CITY OF KIRKLAND
Planning and Building Department
123 Fifth Avenue, Kirkland, WA 98033
425.587-3600 - www.kirklandwa.gov

MEMORANDUM

File No.: DRV16-01636

Subject: LENNAR TOTEM LAKE APARTMENTS
CONCEPTUAL DESIGN CONFERENCE

MASSING OPTIONS | MASSING OPTION E - "MODEL-S" - PREFERRED OPTION

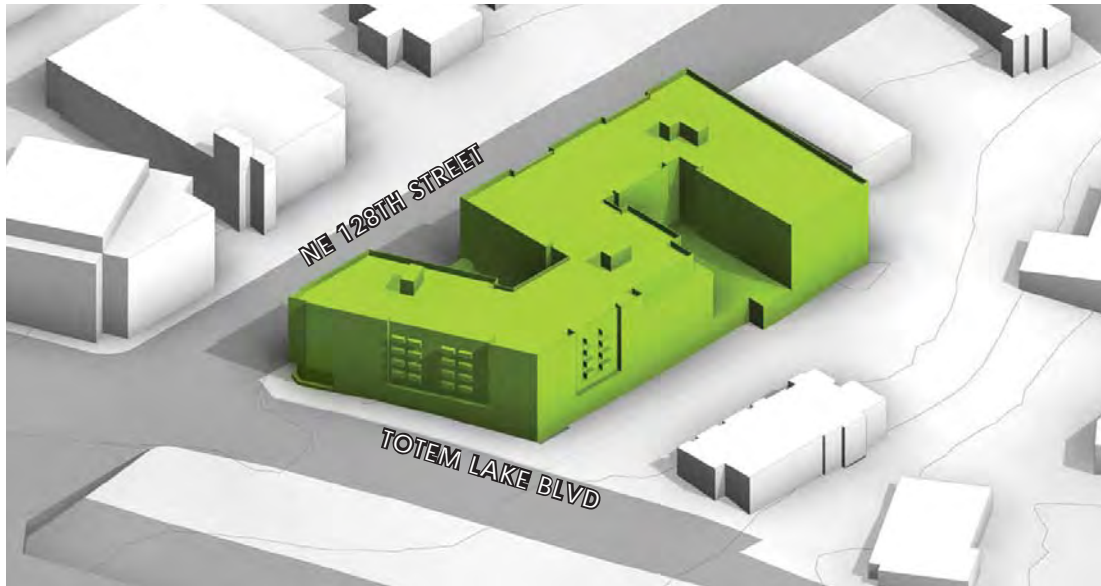
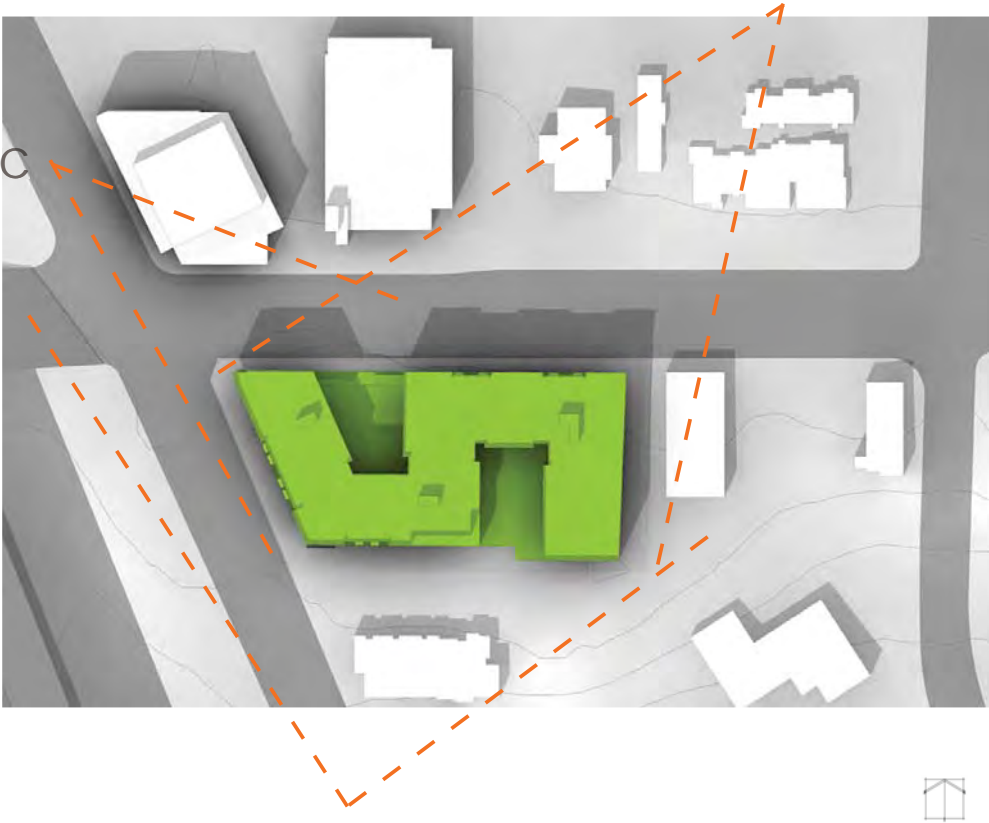
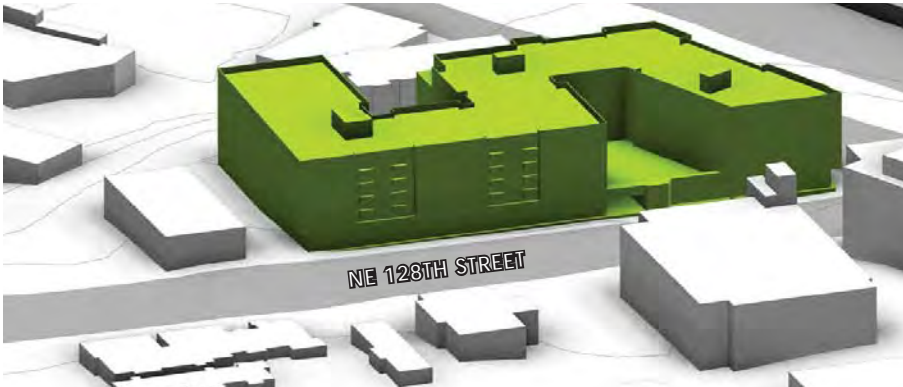
1. What are the key vantages of the project?
2. Identify appropriate mitigation techniques for building massing of the proposed buildings. Possible techniques include vertical and horizontal modulation, corner treatment, and roof forms. The applicant has provided several massing schemes including a preferred option (Option 3) for the DRB's review and comment (see Attachment 2).
